MEMORANDUM

DATE: **February 24, 2014**
TO: **Plan Holders**
FROM: **Ronald J. Pritzlaff, Utility Engineer**
RE: **Addendum No. 1**

The Utility has issued Addendum No. 1 to our Howell Avenue Water Main Relay project. You can download a copy of the addendum from our web site at:

Revised Plan Sheets 1, 2, 3, 4, and 5

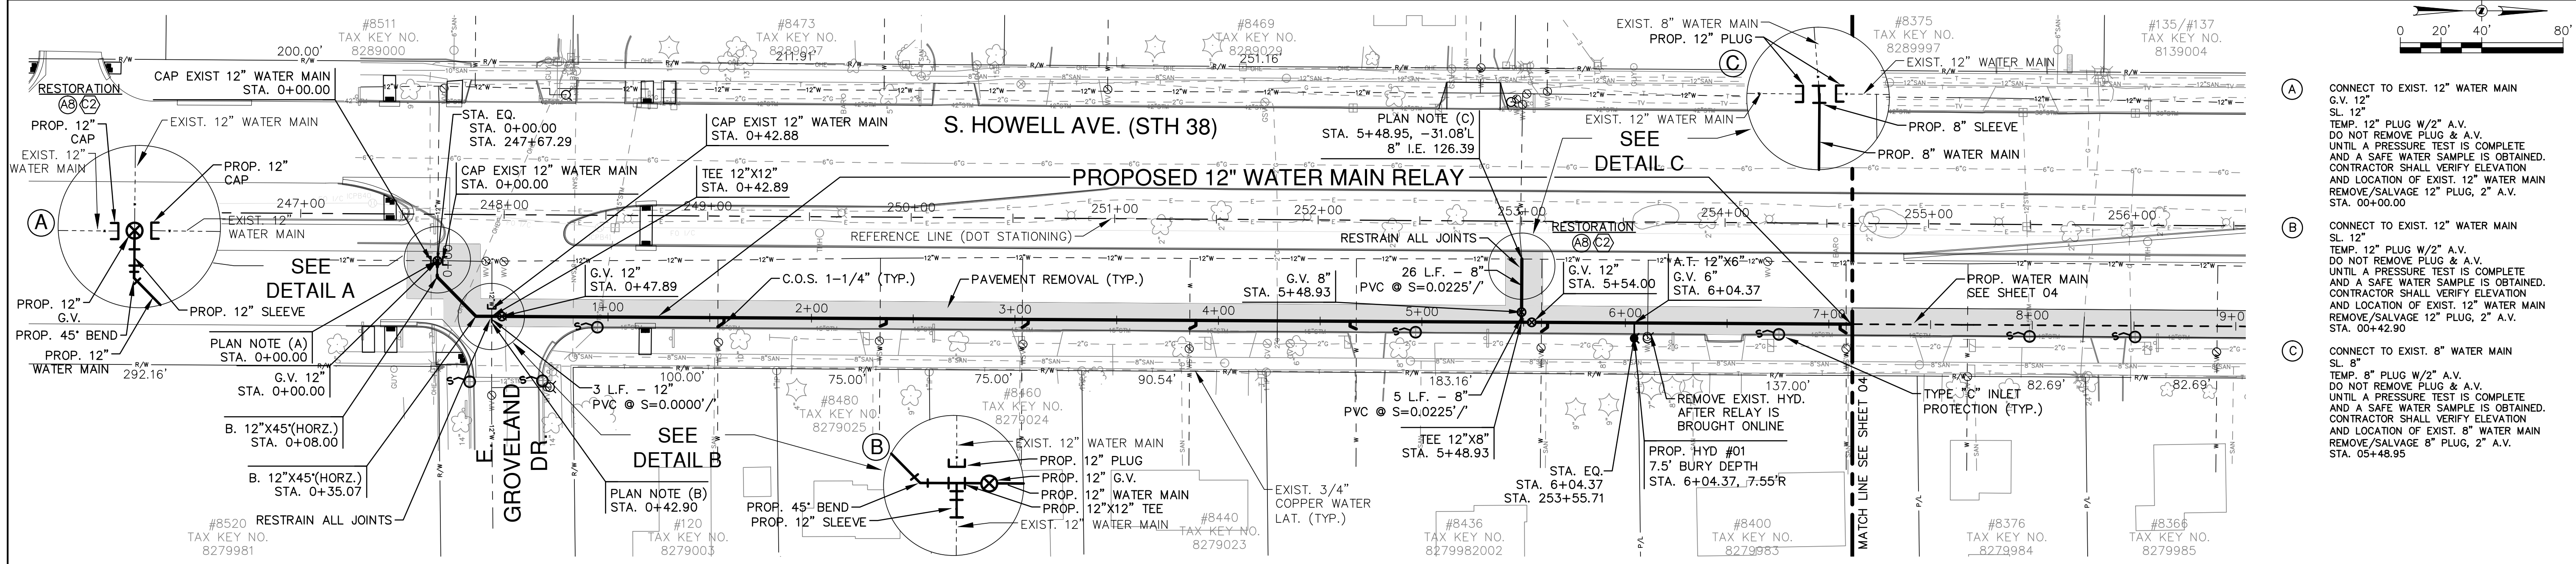
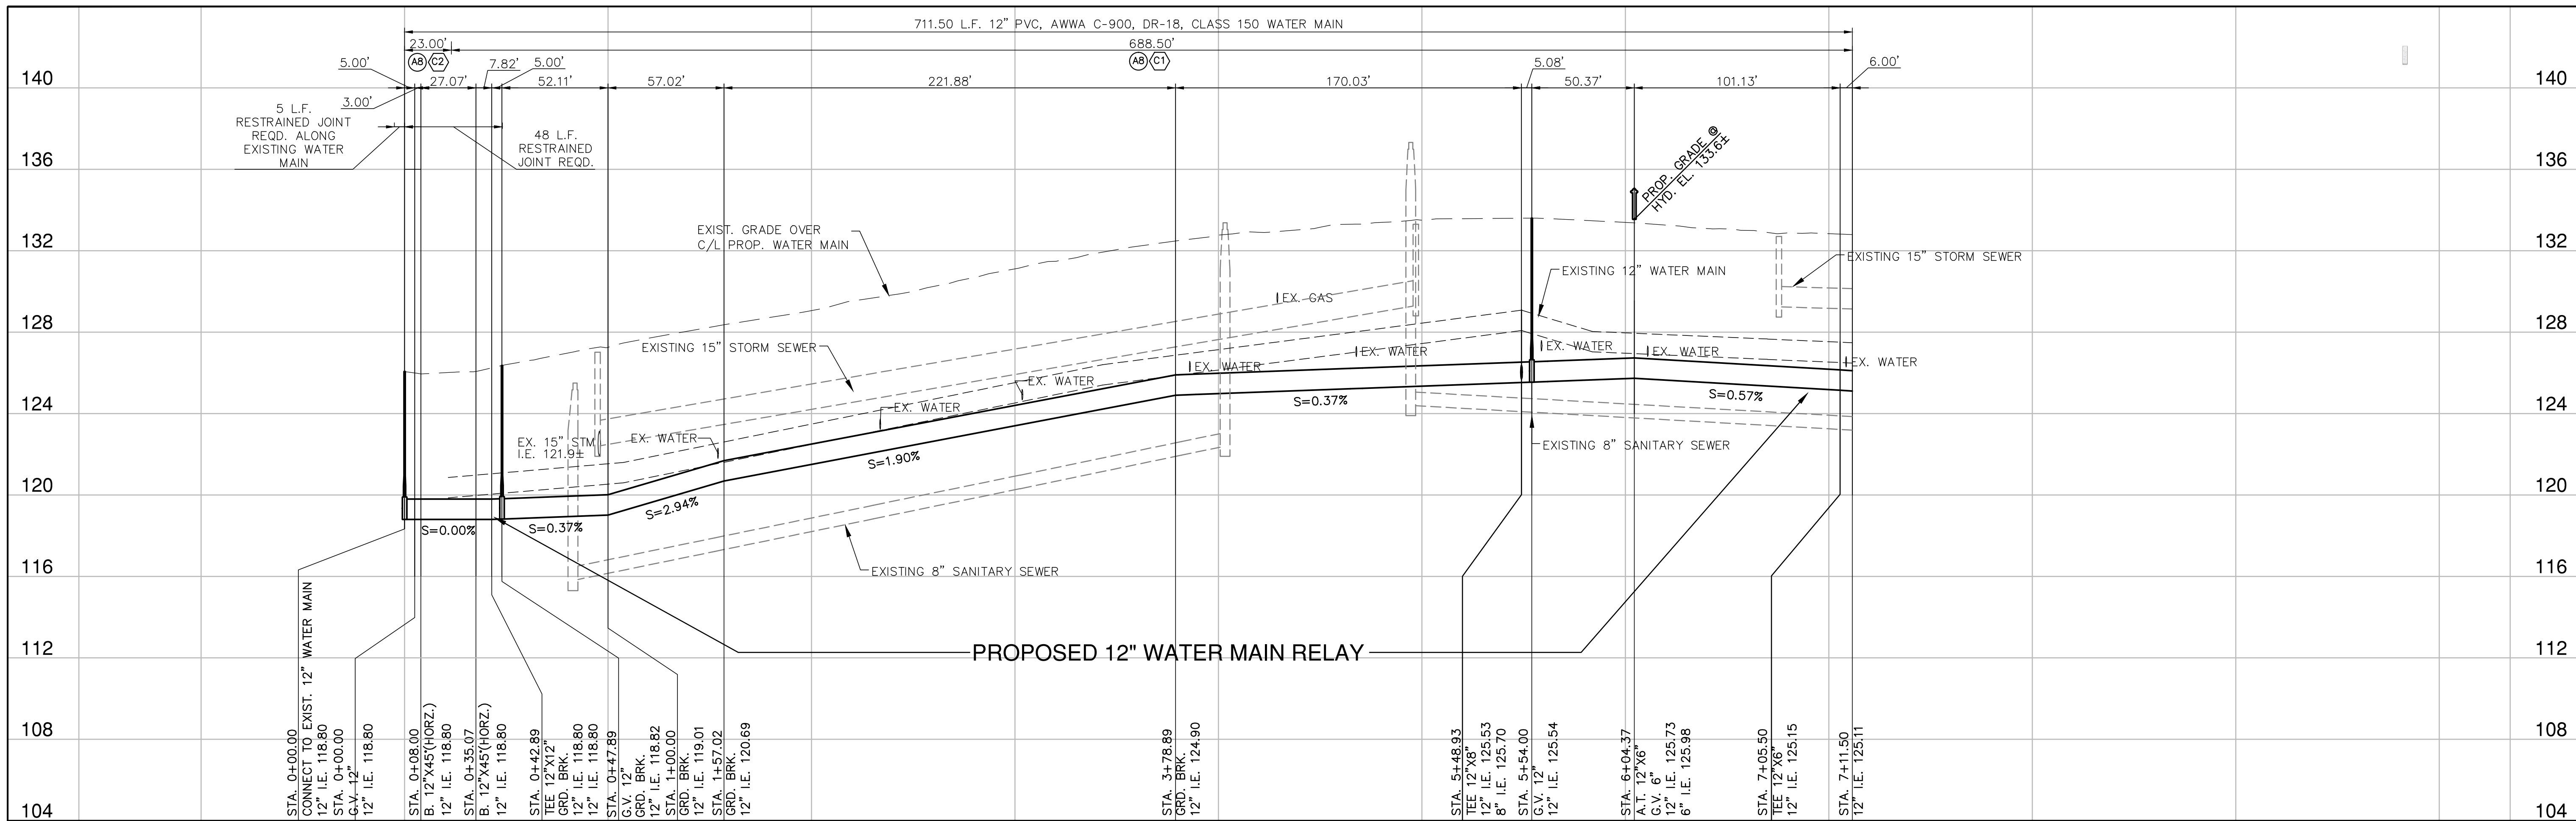
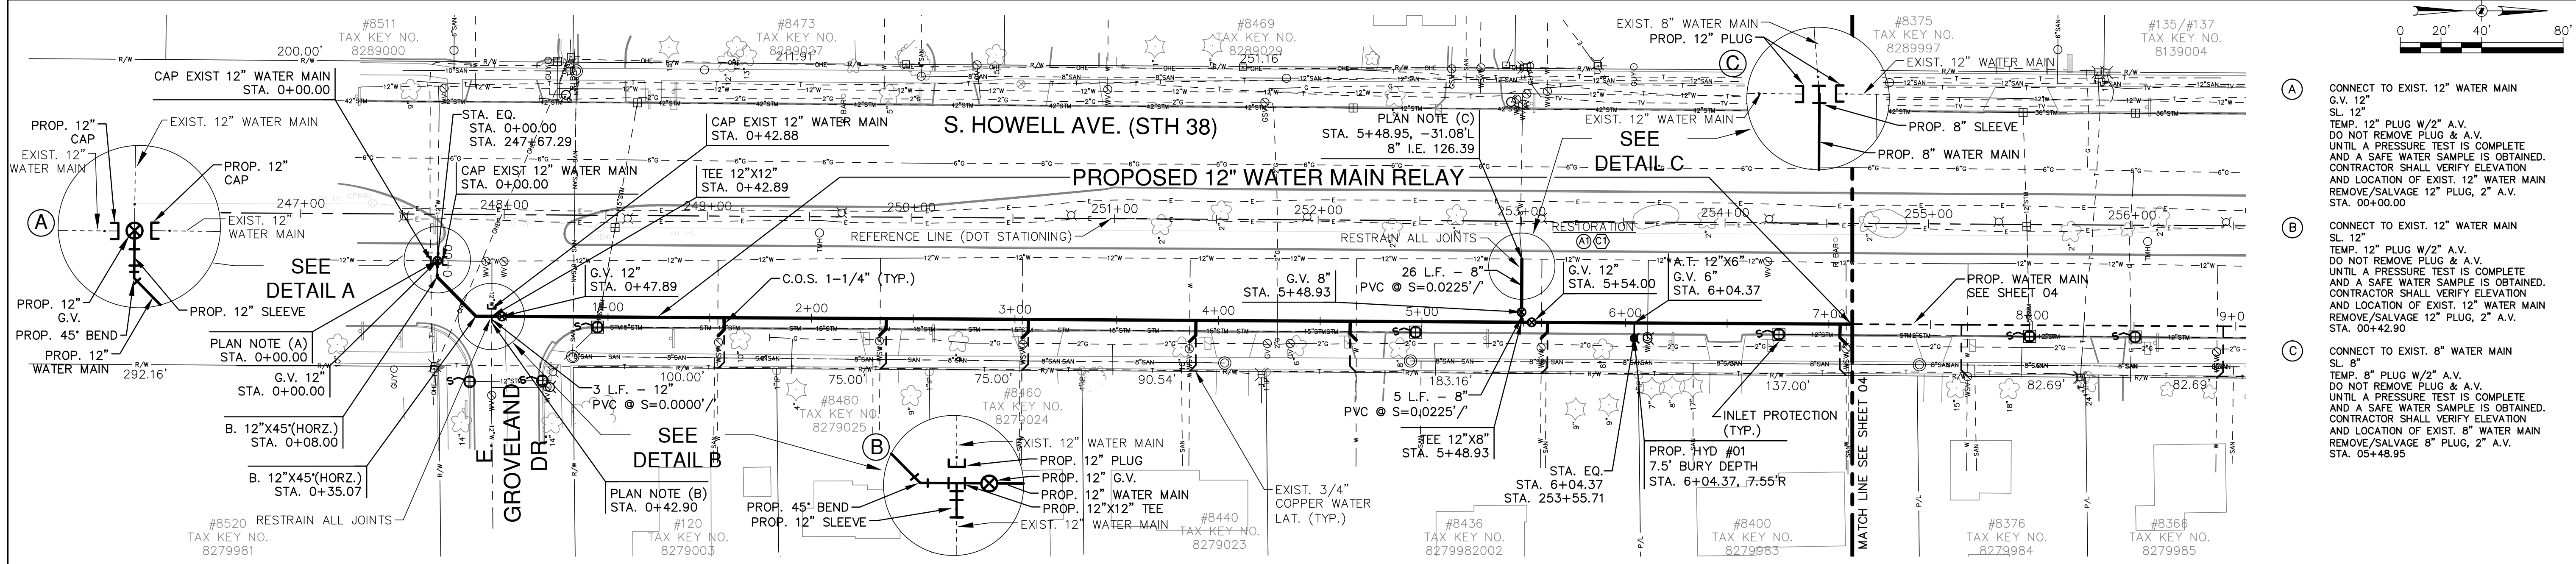
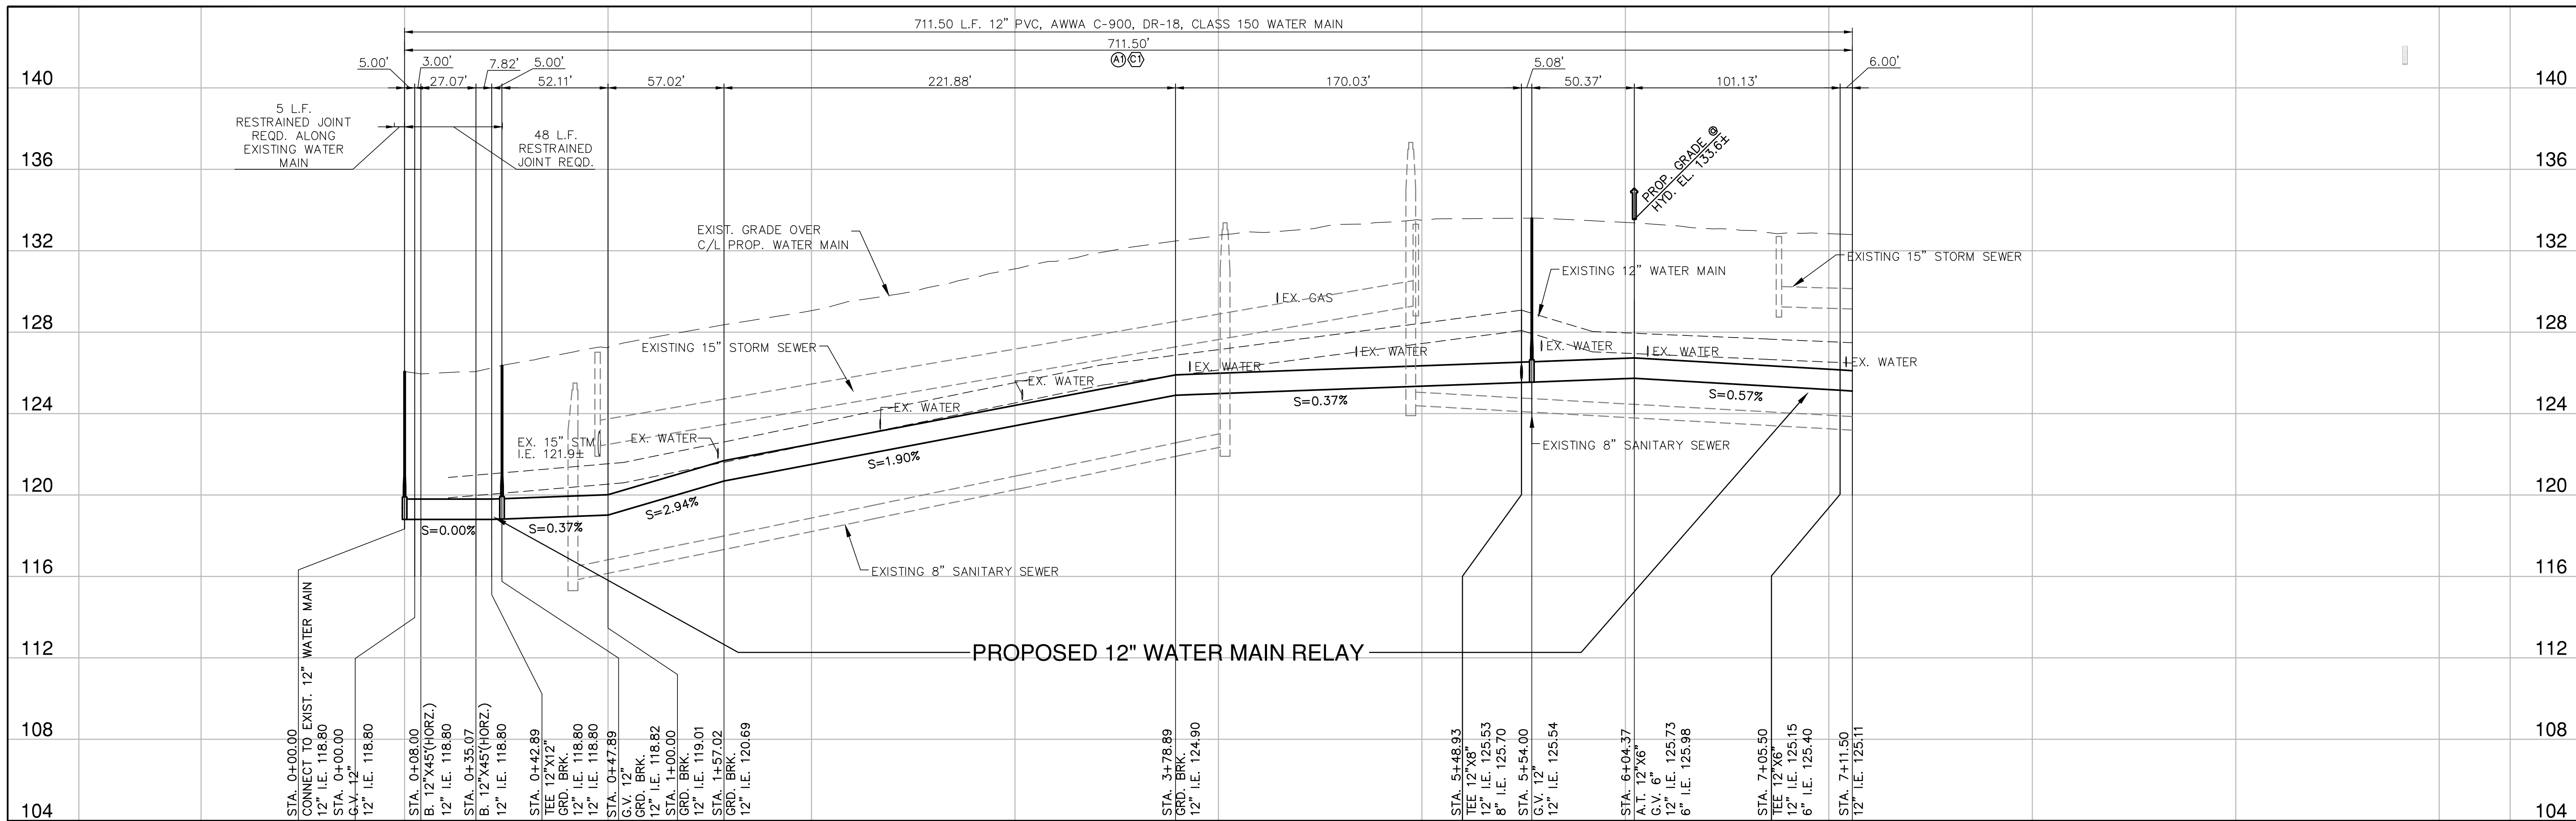
- Replace Schedule One of the Bid Proposal Section in its entirety
- Replace Section VII MATERIALS FOR WATER MAINS, paragraph H in its entirety
- Delete Section VIII MATERIALS GENERAL, paragraph A in its entirety
- Replace Section VIII MATERIALS GENERAL, paragraph B, sub-paragraph 1 in its entirety
- Replace Section X RESTORATION IN THE WORK AREA, paragraph C, sub-paragraph 1 in its entirety
- Replace Section X RESTORATION IN THE WORK AREA, paragraph C, sub-paragraph 2, part B in its entirety
- Replace Section XVI PROPOSAL ITEMS in its entirety
- Replace the Wisconsin Department of Transportation Utility permit in its entirety
- Replace sheet numbers 1,2,3,4, and 5 of the plans in their entirety
